**STAFF REPORT: CITY OF TRINIDAD**

APPLICATION NO: 2012-06

PROJECT LOCATION: 70 Scenic Drive

PROJECT DESCRIPTION: Coastal Development Permit and Design Review to construct a 595 sq. ft. 2-car, attached garage on an existing 2-story, 1,111 sq. ft., 1-bedroom single family residence. Other proposed improvements include a new entry, window, a 212.5 sq ft deck extension, and extending the existing driveway.

**PROPOSED SITE PLAN**  
 SCALE: 1" = 10'-0"

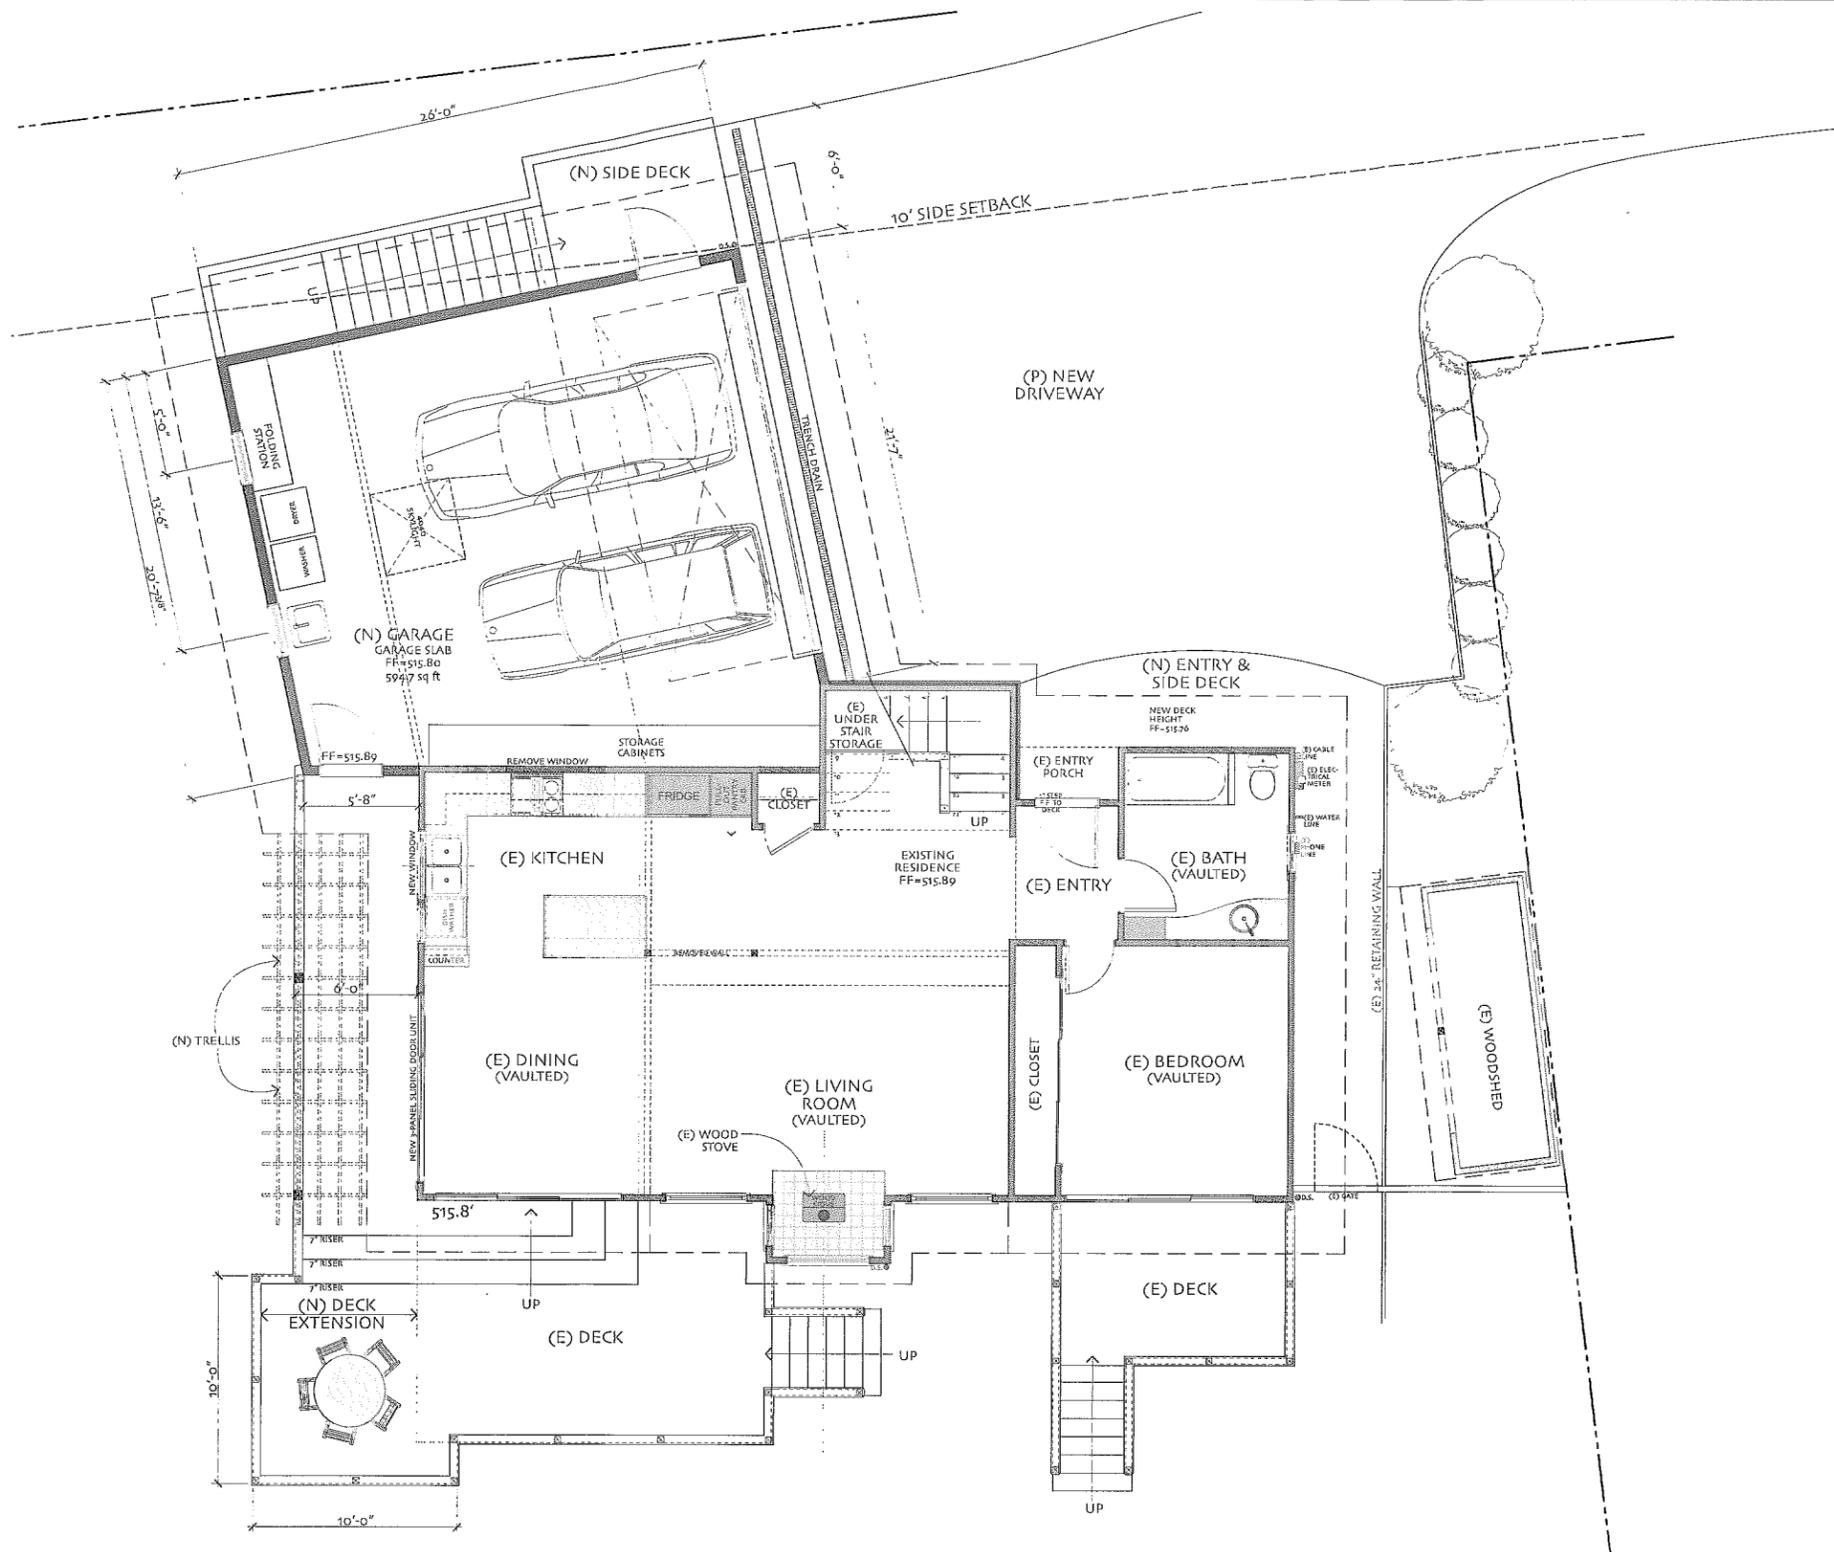
The project area is used as residential property, and the applicants plan on building a garage as an addition to the residence. This attached garage will be used for two cars, and the use will be incidental to the primary use of the premises, and not alter or change the character of the premises. Zoning Ordinance (§17.28.060) states that the minimum yards in the SR zone are: front - thirty feet; rear - twenty feet; and side - ten feet. The garage meets all required yards; the north-facing side of the garage meets the 10-foot yardage exactly.

There is one setback issue that does take a little bit of consideration, and that is with the stairs and landing on the north side of the garage. Section 17.56.110 of the Zoning Ordinance has more specific setback requirements for all zones. Subsection A states: “*Uncovered porches, decks, balconies, stairways, fire escapes or landings may extend a maximum of eight feet into front street-side or rear yards and three feet into side yards.*” However, there are no setback restrictions for things like driveways, retaining walls, patios or walkways, and even accessory buildings can be located fully within a side yard (17.56.090). The proposed stairs and bottom landing extend a maximum of 3 ft. into the side yard, and therefore meet the Zoning Ordinance requirements. However, the ‘landing’ at the top of the stairs extends up to 6 ft. into the side yard where it meets the driveway. It is staff’s opinion that the setback restriction of §17.56.110 is intended for structures that are not at ground level, since it does not include patios, walkways or driveways. Staff feels that the upper landing meets the definition of a walkway or patio just as well as it does a ‘landing.’ Under this interpretation, the structures would meet all the required setbacks, but the Planning Commission could have a different interpretation.

Parking in the SR Zone is regulated by Zoning Ordinance §17.56.180. A single-family residence requires a minimum of two off-street parking spaces in addition to any garage spaces. There is ample room in the driveway to accommodate two or more vehicles. The new driveway extension is proposed to be paved with interlocking concrete pavers with a trench drain adjacent to the new garage. Note that drainage from the driveway and garage roof will be tightlined underground to a suitable outlet in the flat area west of the residence. Recommendations from the geologic / soils report (see below) regarding drainage are required as conditions of project approval.
